SUBJECT: S.P. 6212-167 (T.H. 36 Over Keller Lake) St Paul, MN
Bridge No. 62037 Plan revisions for Abutments and Piers

I've enclosed the revised Plan Sheet Nos. 2R, 10R, 11R, 12R, 13R, 21R, 22R, 23R, 24R, 29R, 30R, 31R, 31AR, 32R, 33R, and 33AR. The details were updated in order to ensure proper fabrication. Please remove and discard Sheet Nos. 2, 10, 11, 12, 13, 21, 22, 23, 24, 29, 30, 31, 32 and 33 in your original plan set and insert the enclosed new sheets. Thank you.

SUBJECT: S.P. 6212-167 (T.H. 36 Over Keller Lake) St Paul, MN
Bridge No. 62037 Plan revisions for Inverted Tee Beams and Deck
Reinforcement

BRIDGE NO. 62037
 SHEET NO. 2R OF 68 SHEETS

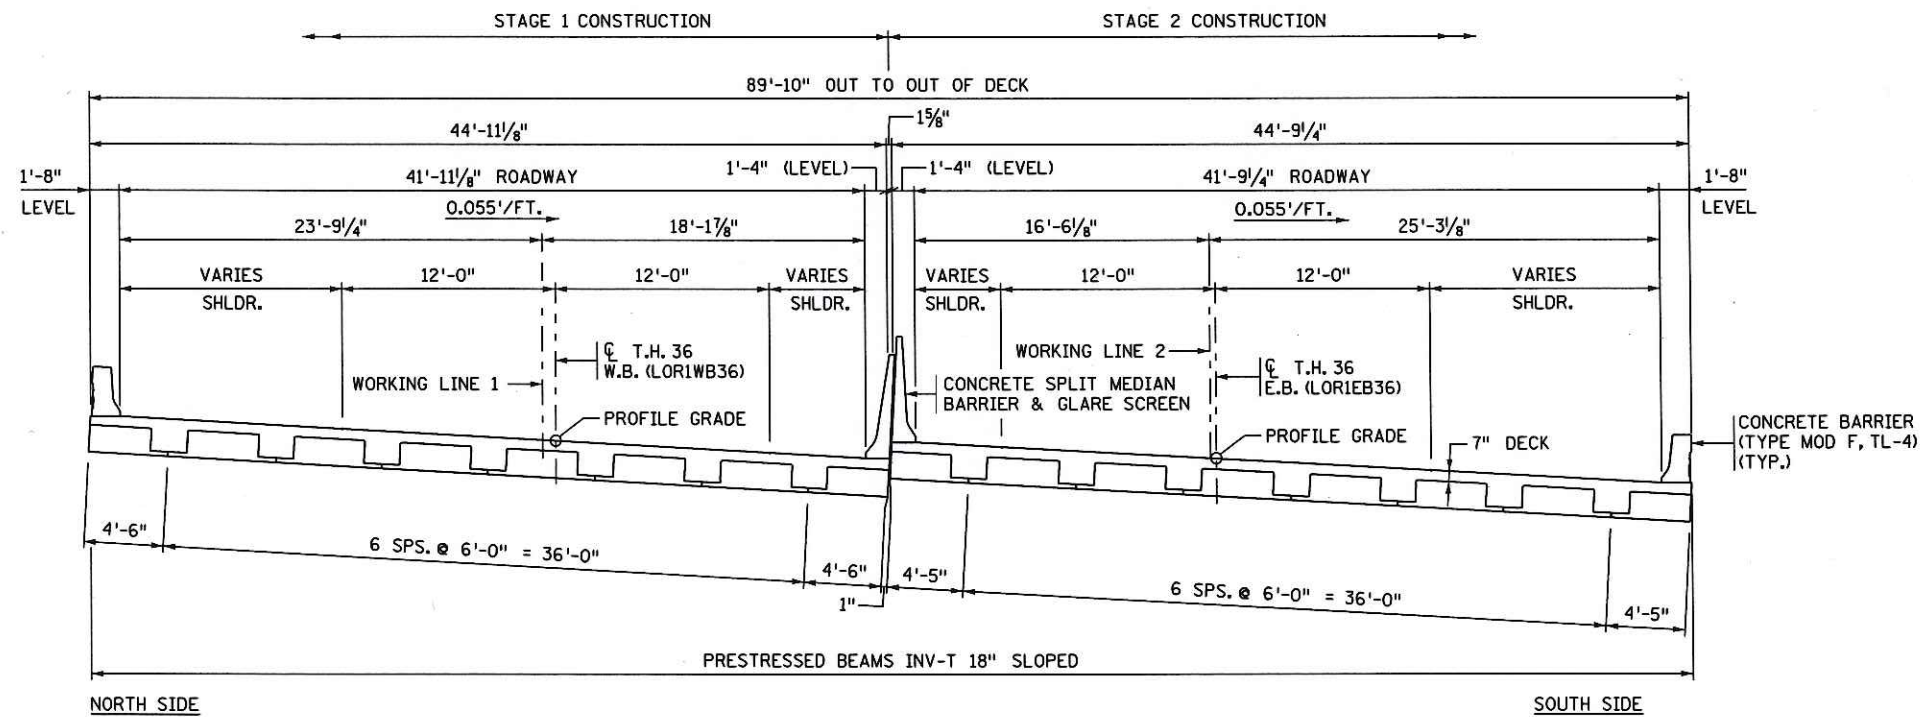
② INCLUDES REINFORCEMENT MODIFICATIONS OF THE PRECAST PIER ELEMENTS; STAGE 1 (350 LBS.) STAGE 2 (360 LBS.) TOTAL (710 LBS.)

③ INCLUDES REINFORCEMENT MODIFICATIONS OF THE PRECAST ABUTMENT ELEMENTS; STAGE 1 (670 LBS.) STAGE 2 (730 LBS.) TOTAL (1400 LBS.)

REVISION		
DATE	DESCRIPTION	APPROVED BY
5-21-2013	ADDED REINFORCING FOR EASE OF FABRICATION	AMS

DES: MDH DR: TKB APPROVED: 8/5/13
 CHK: NJV CHK: DCH
 SHEET NO. 10R OF 68 SHEETS BRIDGE NO. 62037

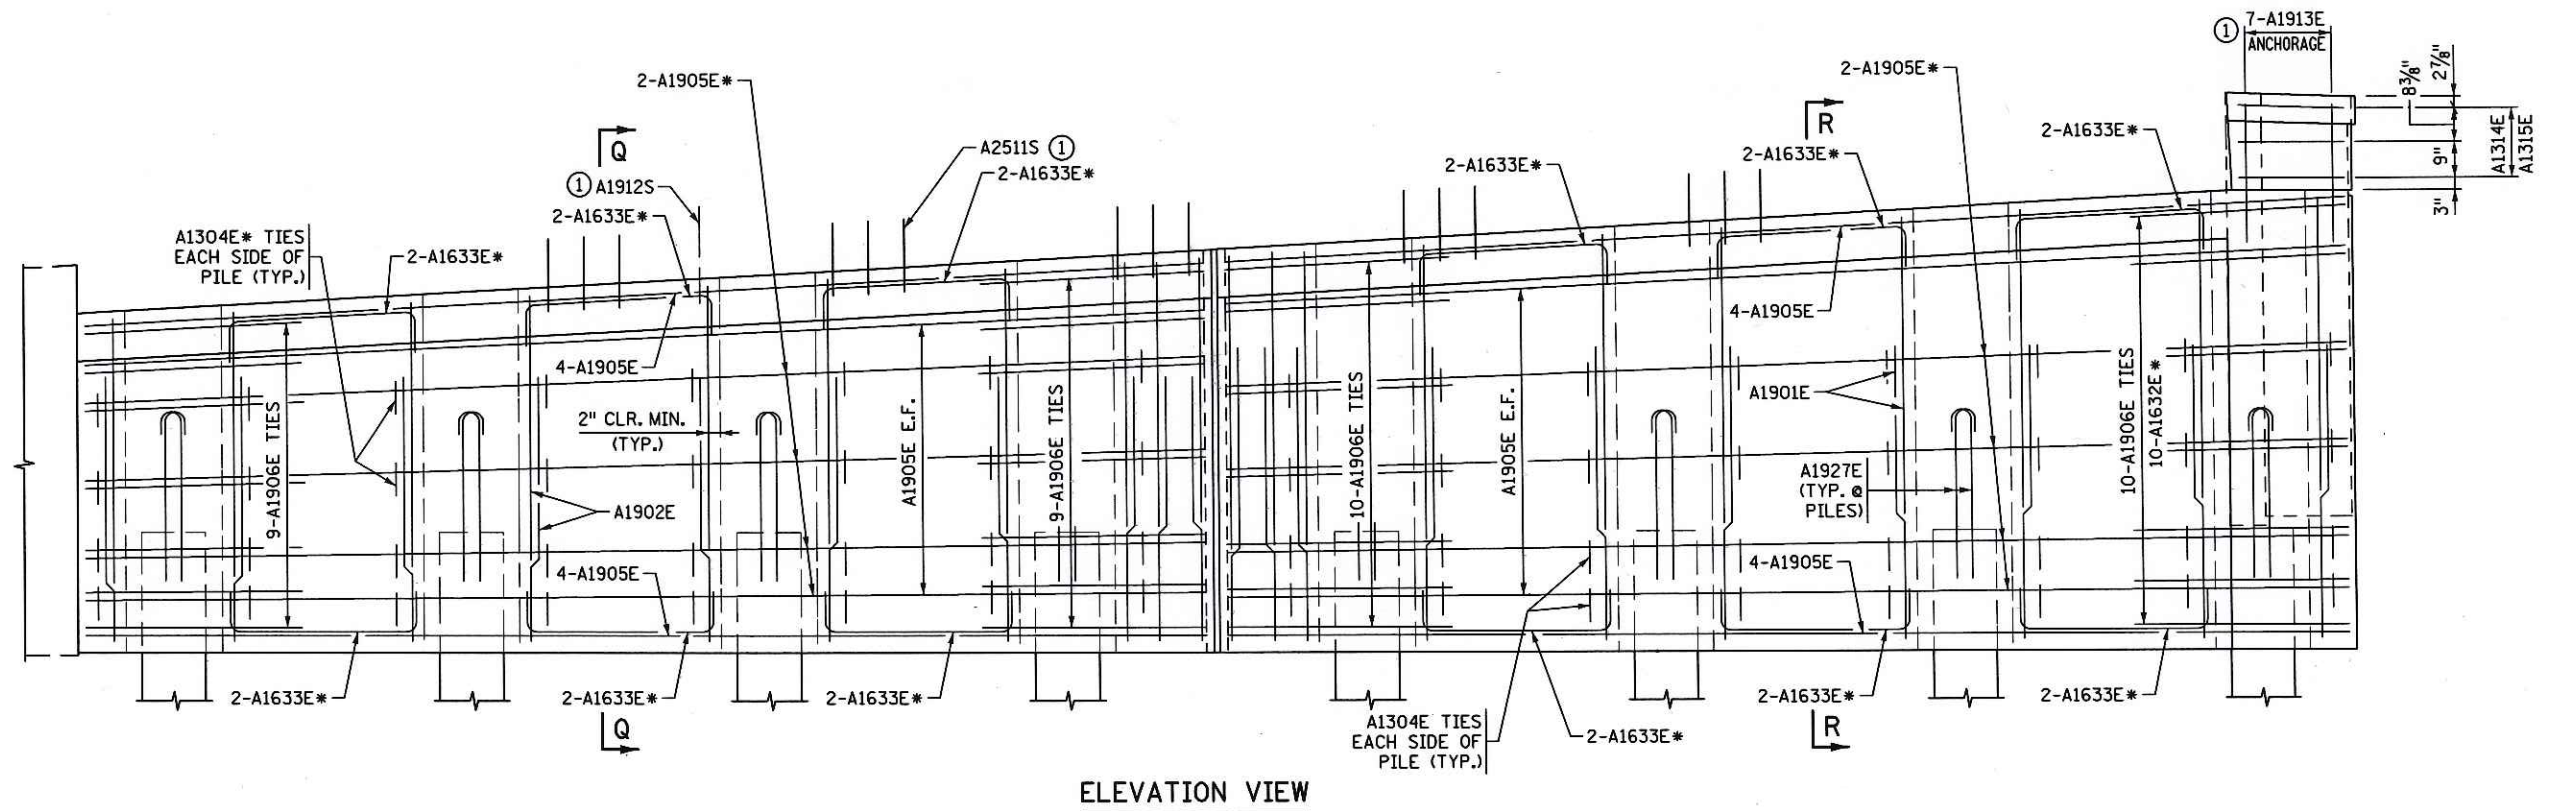
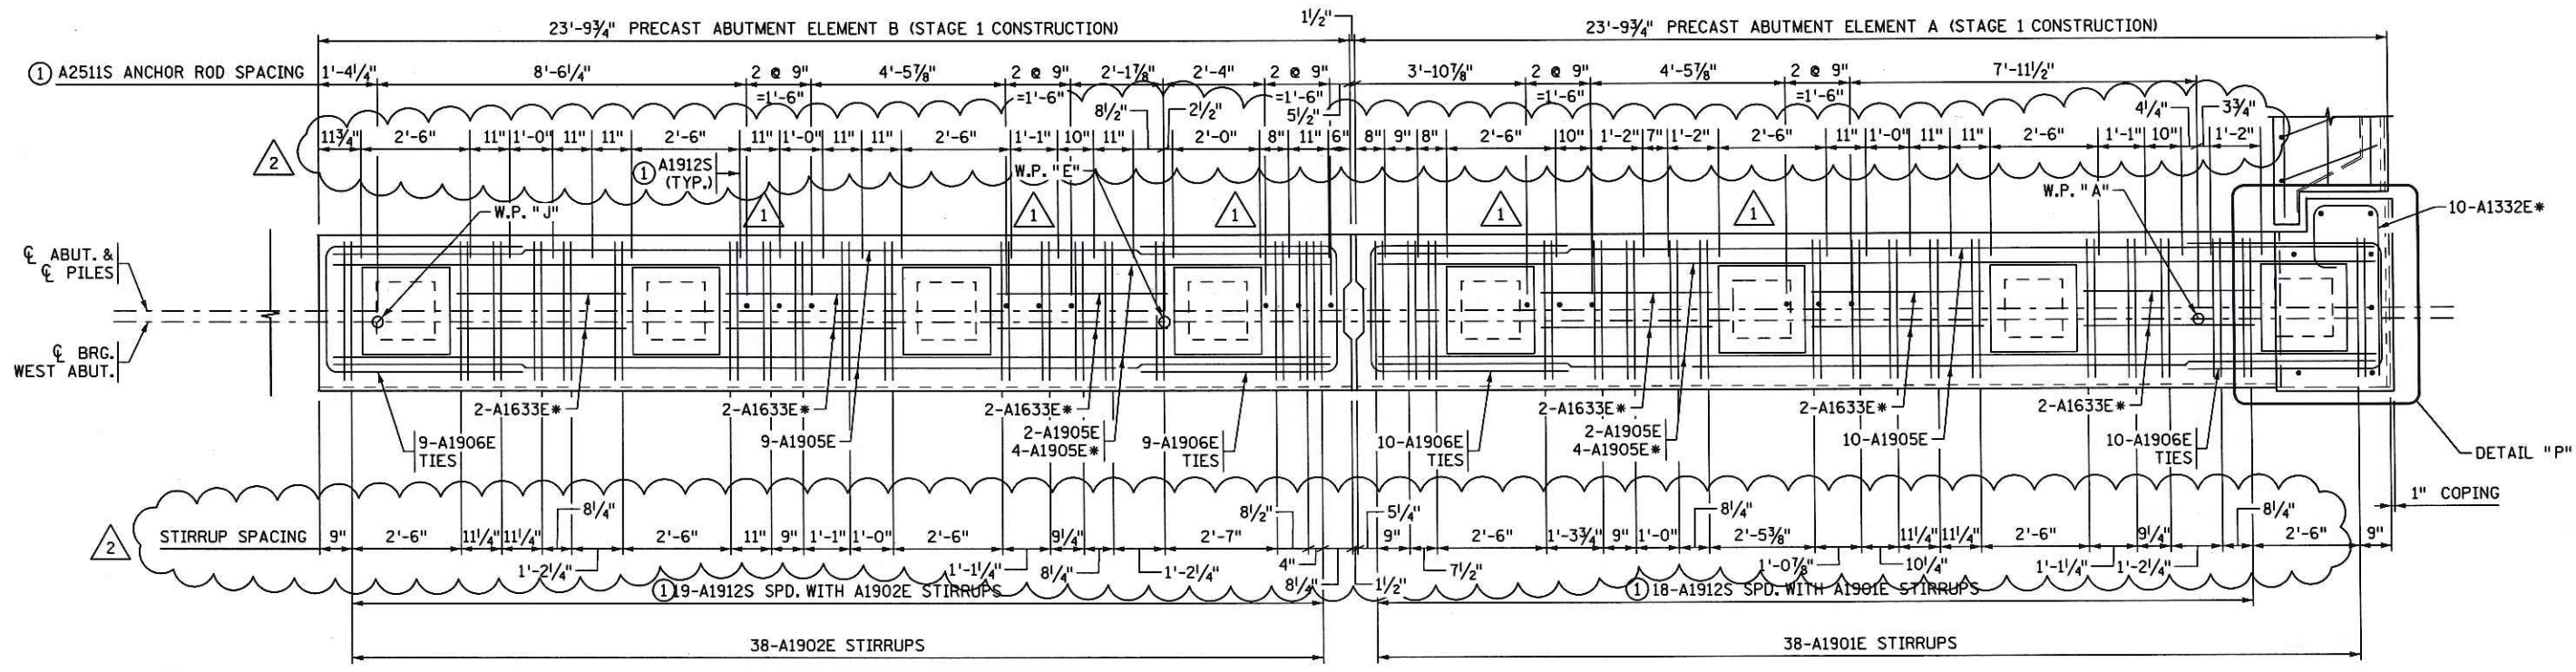
NOTES:
 ① FIELD LOCATE A2511S, A1912S AND A1913E ANCHORAGES TO AVOID DRILLING THROUGH HORIZONTAL REBARS. SEE ANCHORAGE DETAILS. ANCHORAGES TO BE INSTALLED AFTER BEAM PLACEMENT.
 * - DENOTES ADDED REINFORCEMENT. ②

REVISION		
DATE	DESCRIPTION	APPROVED BY
5/3/13	REPOSITIONED A2511S ANCHOR RODS	AMS
5/21/13	ADDED REINFORCING FOR EASE OF FABRICATION	AMS

DES: MDH DR: TKB APPROVED: 8/5/13
 CHK: NJV CHK: DCH
 SHEET NO. 11R OF 68 SHEETS BRIDGE NO. 62037

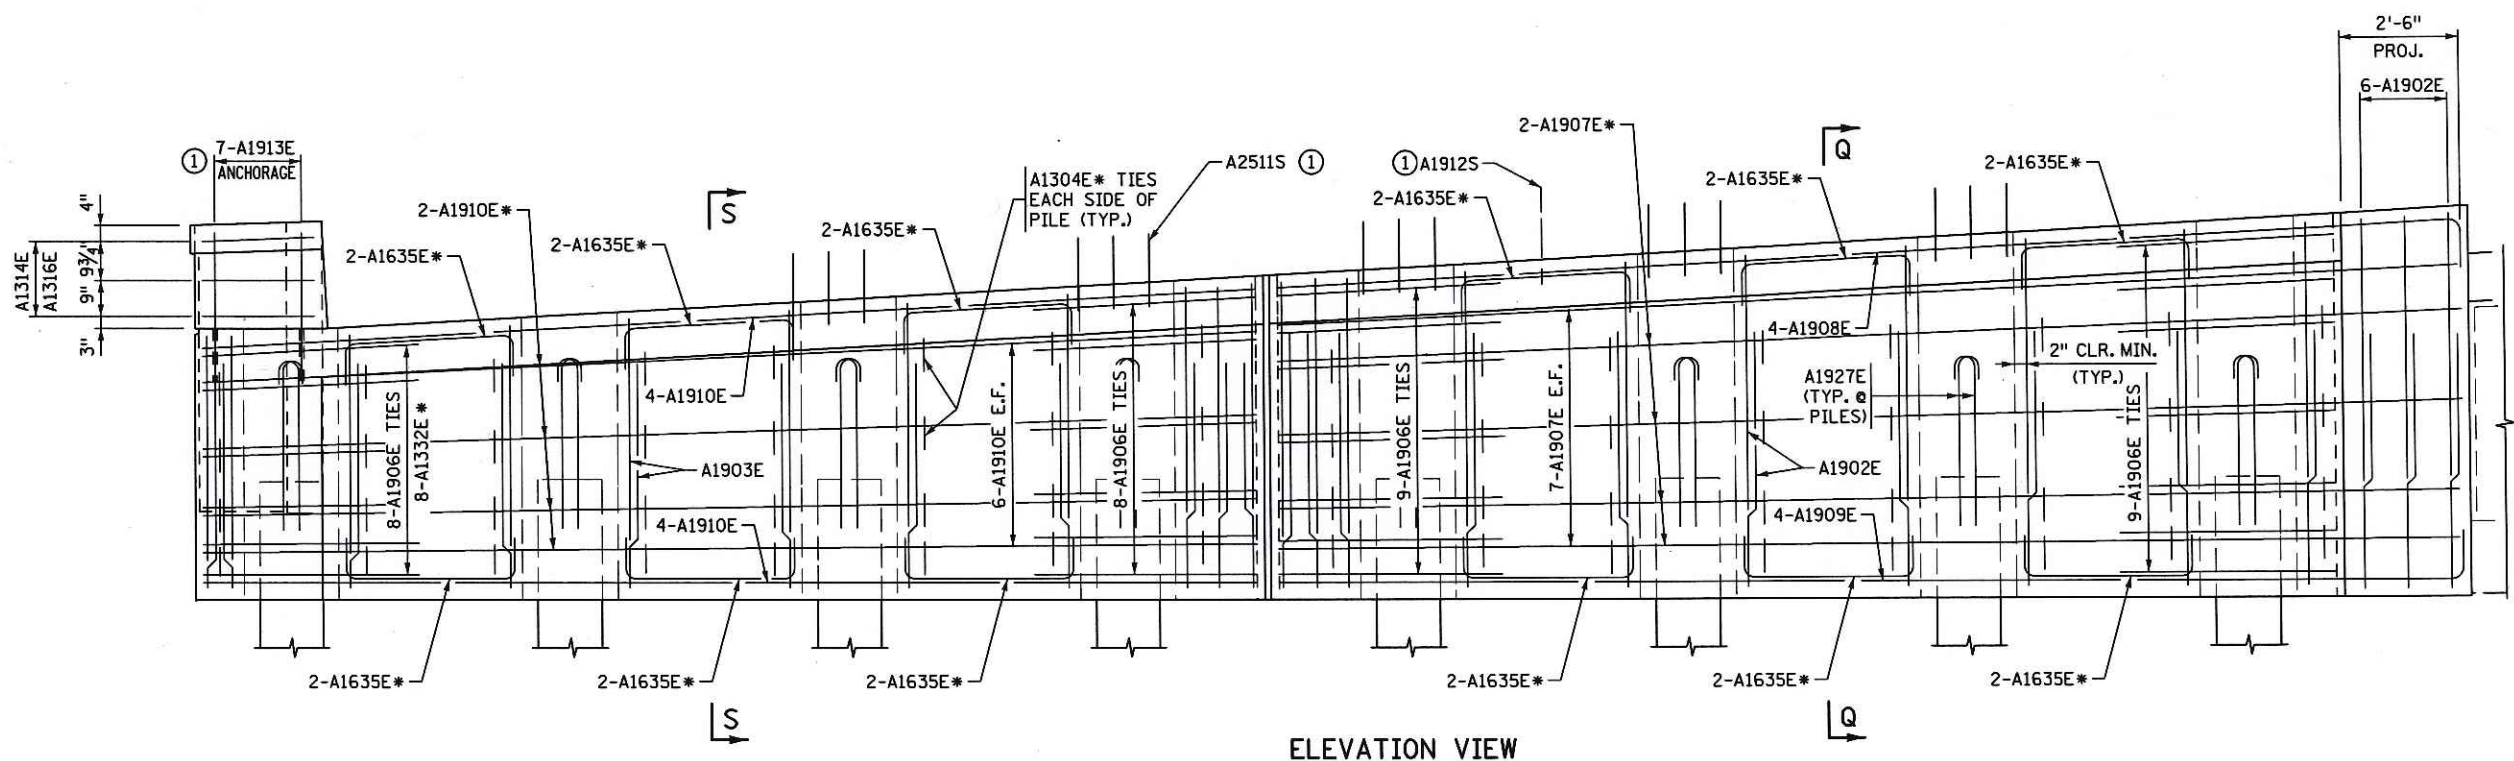
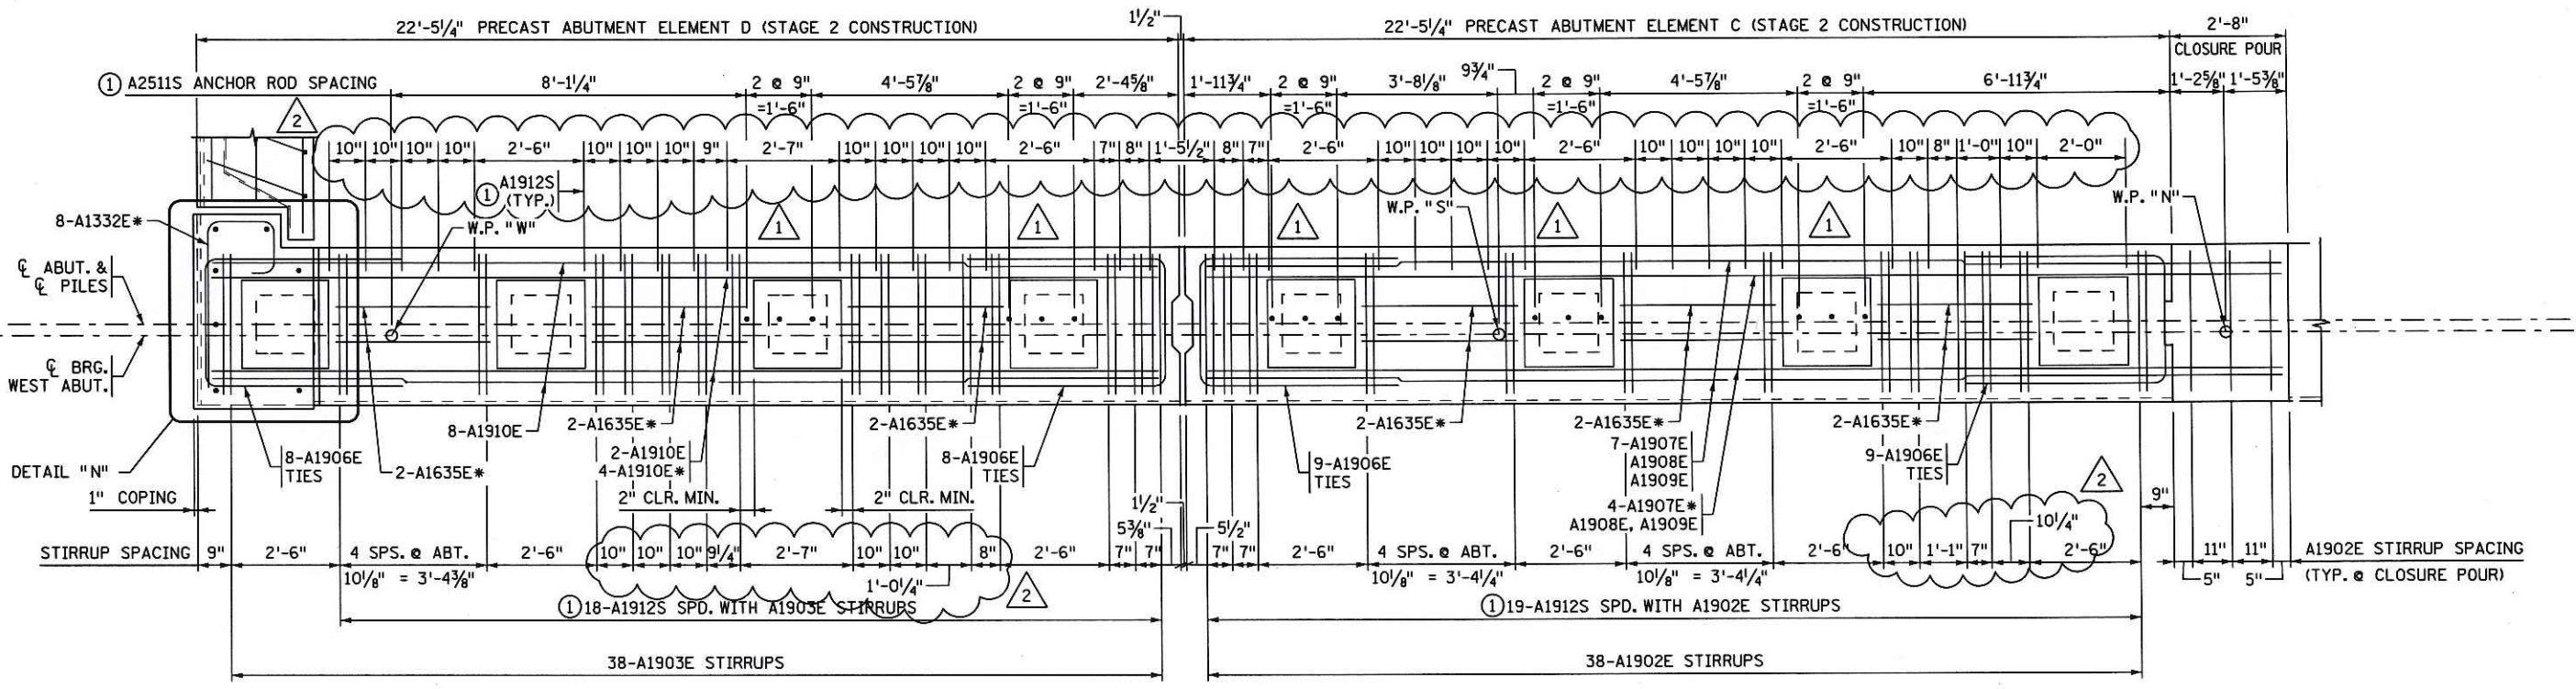
*-DENOTES ADDED REINFORCEMENT.

REVISION		
DATE	DESCRIPTION	APPROVED BY
5/3/13	REPOSITIONED A2511S ANCHOR RODS	AMS
5/21/13	ADDED REINFORCING FOR EASE OF FABRICATION	AMS

DES: MDH DR: TKB APPROVED: 8/5/13
 CHK: NJV CHK: DCH
 SHEET NO. 13R OF 68 SHEETS BRIDGE NO. 62037

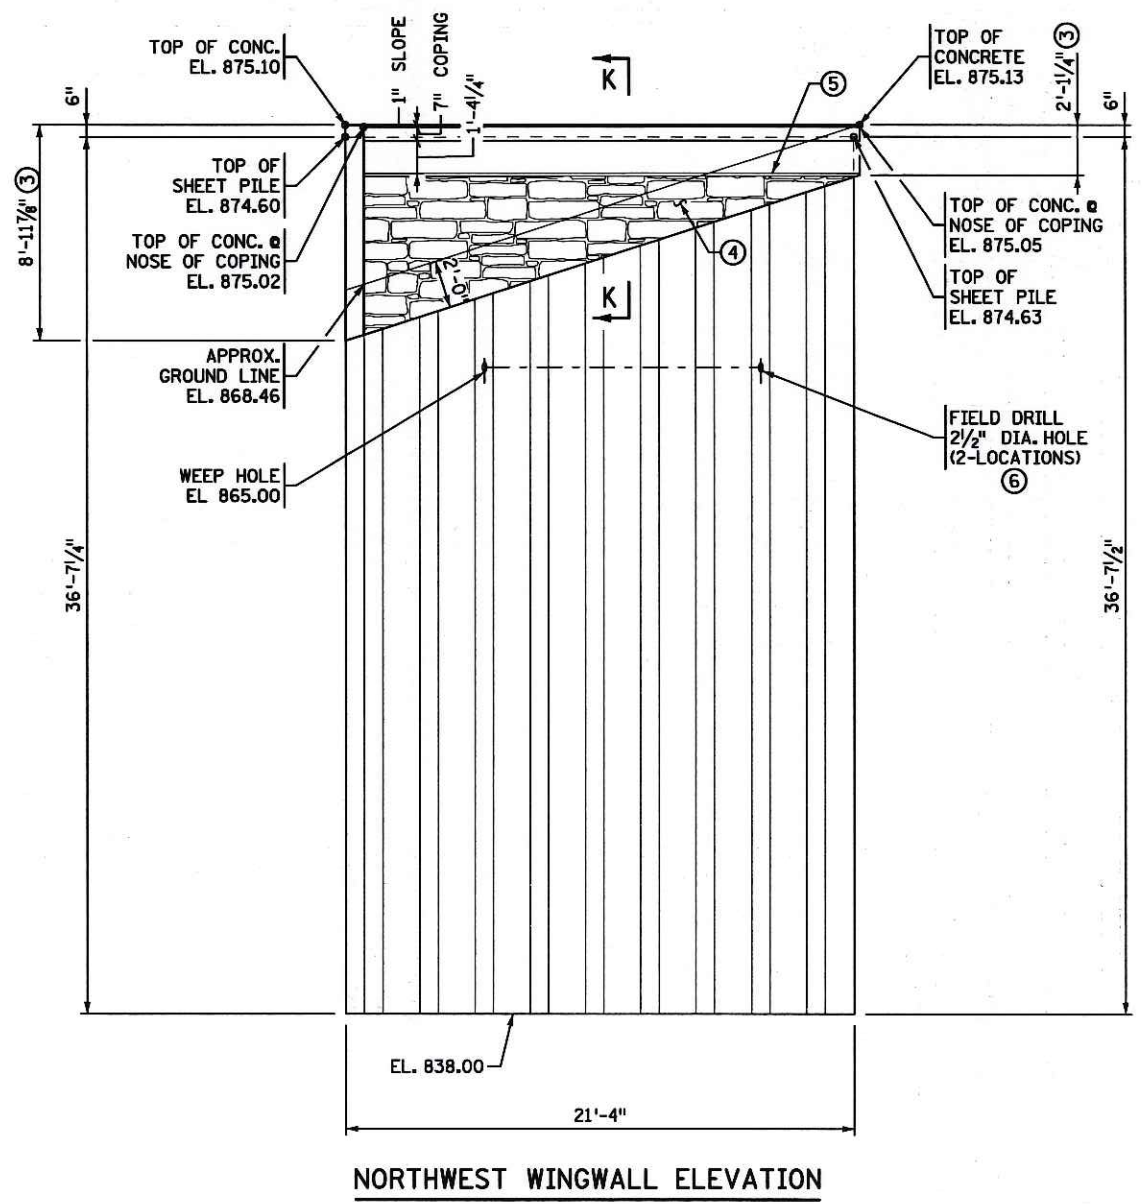
⑤ A1304E ADDED 64 ADDITIONAL BARS
 A1905E ADDED 10 ADDITIONAL BARS
 A1907E ADDED 8 ADDITIONAL BARS
 A1910E ADDED 4 ADDITIONAL BARS

REVISION		
DATE	DESCRIPTION	APPROVED BY
5/21/13	ADDED REINFORCING FOR EASE OF FABRICATION	AMS
